HISTORIC AND DESIGN REVIEW COMMISSION

HDRC CASE NO: 2022-346
ADDRESS: 506 STIEREN
LEGAL DESCRIPTION: NCB 2966 (STIEREN STREET REPLAT), BLOCK 1 LOT 18
ZONING: RM-4, H
CITY COUNCIL DIST.: 1
DISTRICT: King William Historic District
APPLICANT: caroline gado
OWNER: APOLLO MAYORAL LLC
TYPE OF WORK: New construction of four, multi-story structures
APPLICATION RECEIVED: September 09, 2022
60-DAY REVIEW: Not applicable due to City Council Emergency Orders
CASE MANAGER: Rachel Rettaliata

The applicant is requesting a Certificate of Appropriateness for approval to construct four residential structures on the lot addressed 506 Stieren. The proposal includes three, 3-story structures and one, 2-story structure.

3 SITE PLAN
3/32" = 1'-0"

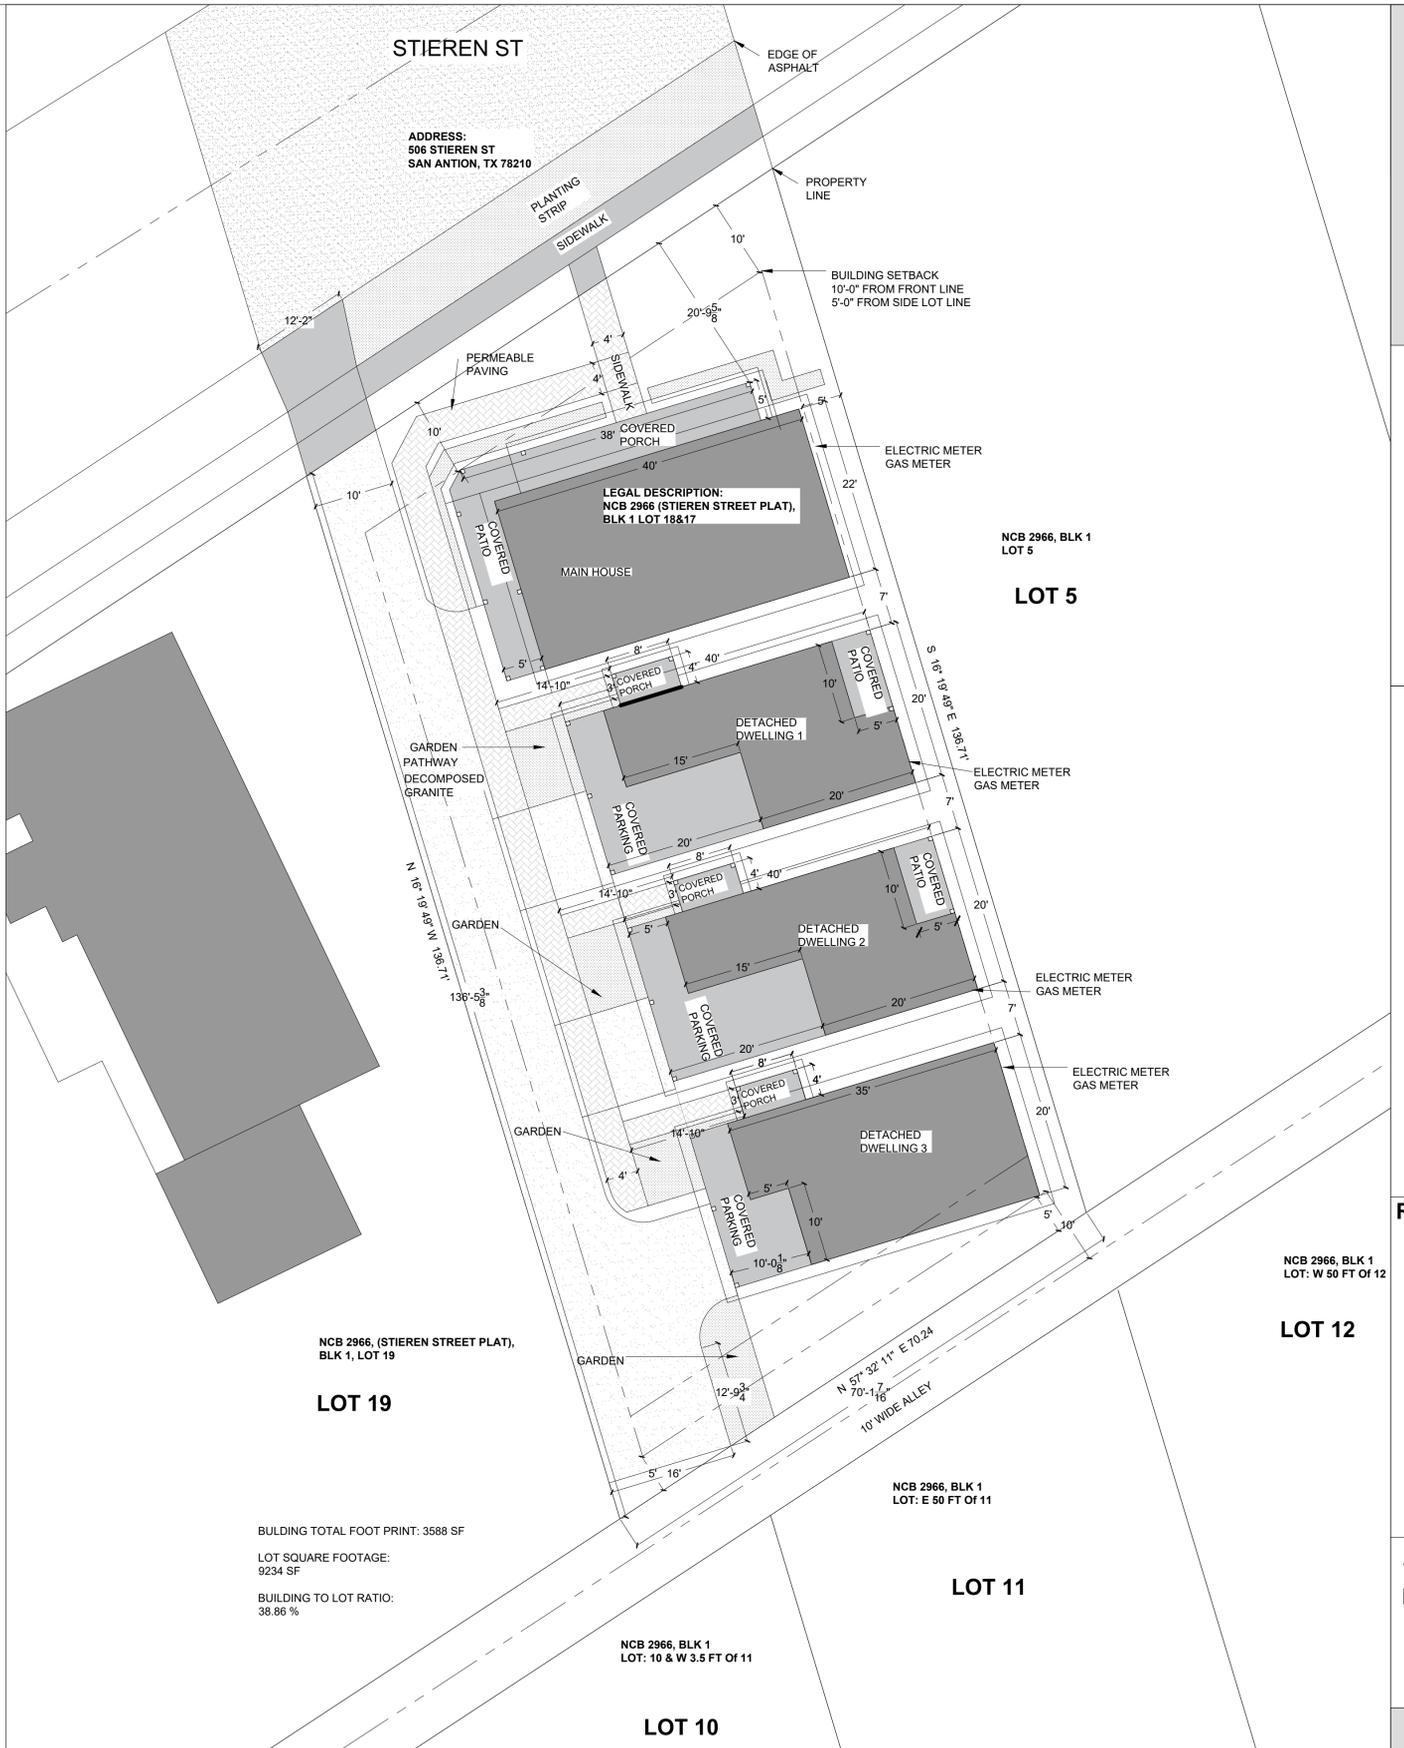
- e. LOT COVERAGE – Per the submitted conceptual site plan, the front unit along Stieren will have the largest footprint of the four structures, with the three interior structures featuring a similar overall rectangular footprint. The documents include a lot coverage calculation for the building footprint, which states that the overall lot measures 9,234 square feet, the total building footprint measures 3,588 square feet, for a building-to-lot ratio of 38.86%. According to the Historic Design Guidelines, new construction should respond to the existing development pattern of the district and buildings and impervious coverage should not exceed 50% of the lot. Historic lots in the district do not traditionally have four detached structures. The predominant development pattern for residential lots is a larger primary structure and a smaller detached accessory structure in footprint. While the building footprints total less than 50% coverage of the lot, a calculation for total impervious cover is not provided. Staff does not find the proposed footprint consistent with the Guidelines. Staff finds that the applicant should explore a revised site configuration and building number that is more consistent with historic development patterns and lot coverage found in the neighborhood.

- k. DRIVEWAY AND PARKING – The applicant has proposed to install a shared common drive along the western edge of the property. The garage on the street-facing structure and carports on the three (3) rear structures are located on the west elevations facing the side drive, embedded within the mass of the structure. The submitted elevation drawings do not accurately reflect proposed conditions, such as the proposed parking pads. Per the Guidelines, the predominant garage orientation found along the block should be matched. Do not introduce front-loaded garages or garages attached to the primary structure on blocks where rear or alley-loaded garages were historically used. Staff finds the attached garage configuration inconsistent with the Guidelines. Staff finds that detached garage or parking areas should be utilized instead of attached garages and carports on the primary structures.

- ii. That the applicant increases the setback of the front unit to be more consistent with the development pattern of the district as noted in findings d and j.

- x. That the applicant reduces the proposed impervious coverage to be introduced by the proposed buildings and hardscaping where feasible and submits an updated site plan showing the widths of the proposed parking pads to staff for review and approval based on finding n. The applicant should indicate all mechanical equipment on the site plans and/or elevations, including condenser units.

HEIGHT STUDY

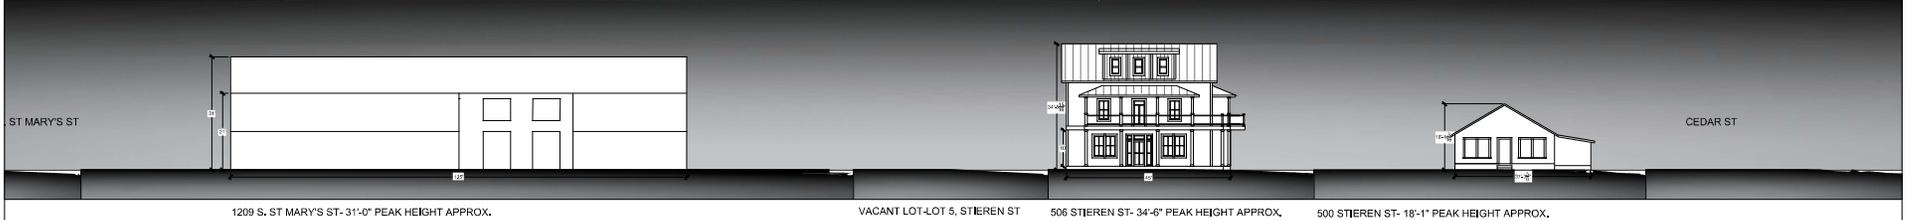
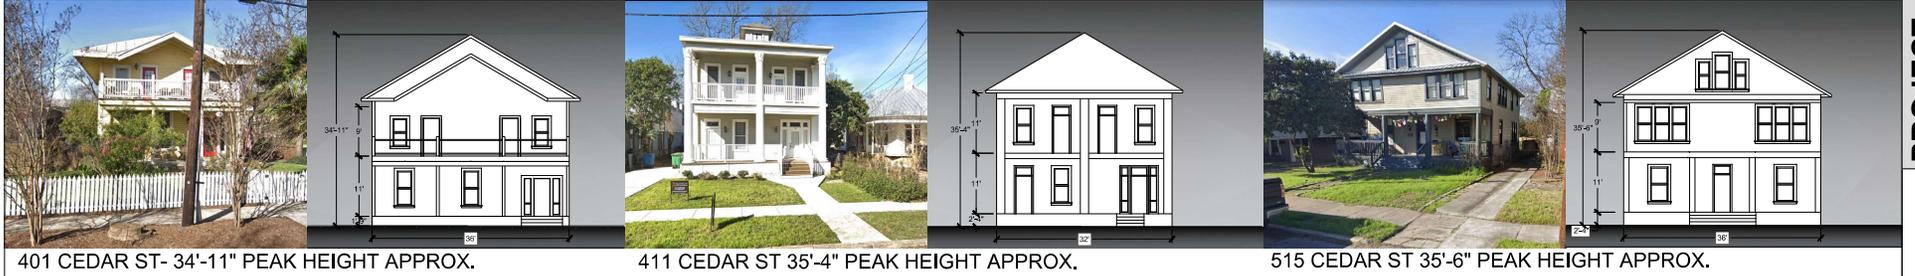
- f. SCALE & MASSING – The applicant has proposed to construct four detached residential structures, including three, 3-story residential structures and one, 2-story residential structure. The front building along Stieren will feature the tallest height at approximately 34'-6", with the remaining houses stepping down in height as the lot moves south from 33'-3" to 30'-9" to 27'-3". According to the Historic Design Guidelines, new construction should not exceed the height of the majority of existing structures by more than 1-story. The predominant surrounding residential context features 1-story residential and commercial structures. While there is a presence of 2- and 2.5-story historic structures peppered along Cedar St, these taller structures typically feature a deeper setback than the 1-story structures. Staff does not find the proposed height consistent with the Guidelines.

- iii. That the applicant reduces the height of the front structure to 2 ½-stories as noted in finding f.
- iv. That the applicant reduces the heights of all three of the rear three structures to be subordinate to the primary structure as noted in finding f.

- v. That the applicant submits an accurate line-of-sight study from both Stieren and Cedar that illustrates the proposed structures in context with the surrounding block.
